**White Salmon Planning Commission Meeting  
A G E N D A  
October 09, 2024 – 5:30 PM  
119 NE Church Ave and Zoom Teleconference**

Cherry Hill Estates Preliminary  
Plat

WS-SUB-2024.001 and WS-SEPA-2024.001  
Applicants: Alex Pedroza of HRK Engineering &  
Field Services, representing Cherry Hill NW, LLC  
and Cameron Curtis of Legacy Development  
Group

**STAFF RECOMMENDATION**  
September 25, 2024

Figure 7 Safe Routes to School Network and County Extensions

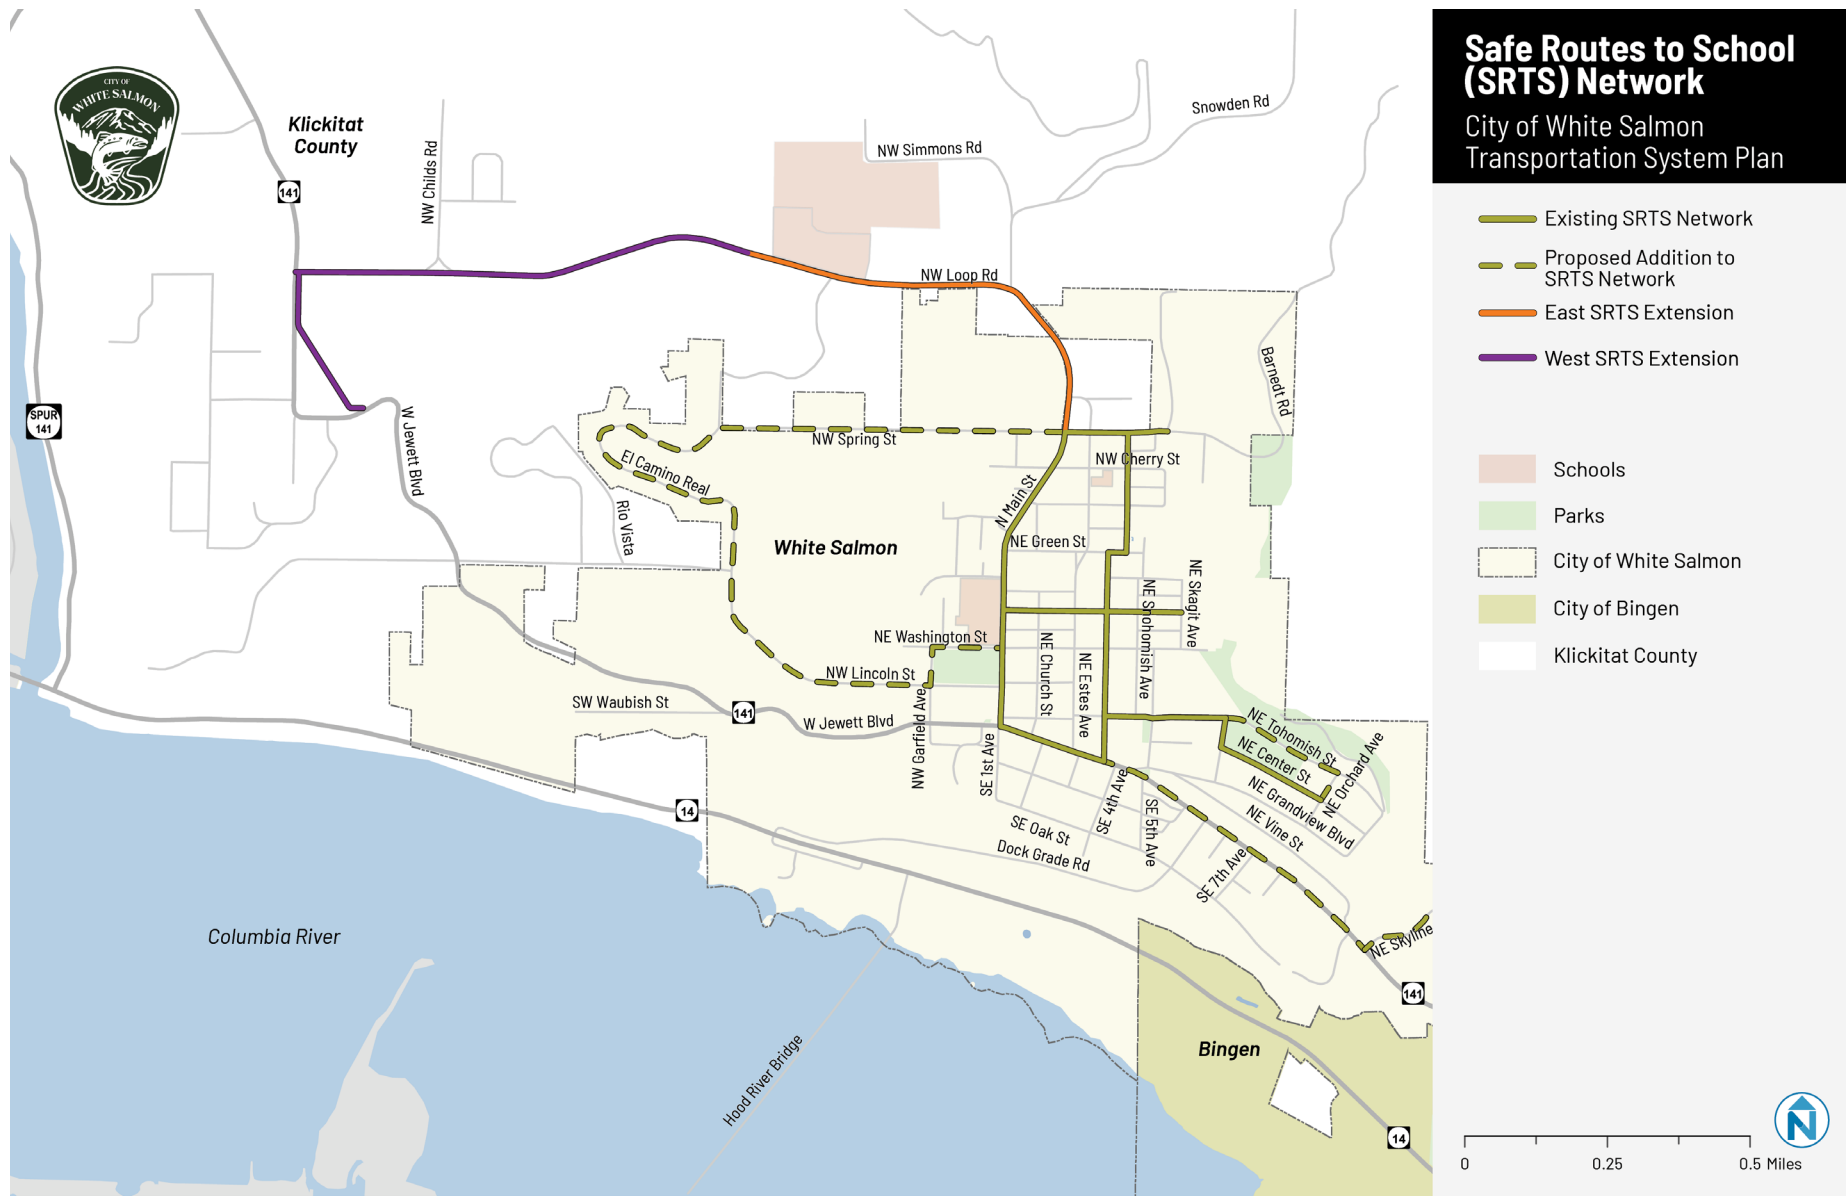
**FINDING:** Per RCW 47.04.30 and the adopted Safe Routes to School network shown on Figure 7 of the TSP and described on page 3-10 of the TSP, staff finds frontage improvements along NW Spring St per the adopted Safe Routes to School network shown on Figure 7 of the TSP and described on page 3-10 of the plan (Exhibit 12b) are needed. If the City receives funding and constructs these improvements on the north side of NW Spring Street prior to final plat, the City may elect to waive this requirement.

- Per the City's recently-adopted Transportation Systems Plan (TSP) "Lite", (August 30, 2023), the City will require extended frontage improvements along NW Spring Street, per the adopted Safe Routes to School network shown on Figure 7 and described on page 3-10 of the plan (excerpt attached). This includes extending right-of-way frontage improvements east 127 feet from the project's entrance to where Lot 2 of the original Cherry Hills Estates Plat SP 91-17 terminates (1001 NW Cherry Hill Rd, parcel 03102475000200). Improvements must be installed or bonded prior to issuance of a future building permit certificate of occupancy.

**CONDITION OF APPROVAL:** Prior to issuance of a future building permit certificate of occupancy, frontage improvements meeting Public Works standards must be installed or bonded for at the intersection of the access road and NW Spring St and running east roughly 125 linear feet. These improvements will be required for half of NW Spring St including a 11’ travel lane, 6’ bike lane, and 5’ sidewalk. The improvements shall join and provide a transition with the existing NW Spring St to provide safe access.
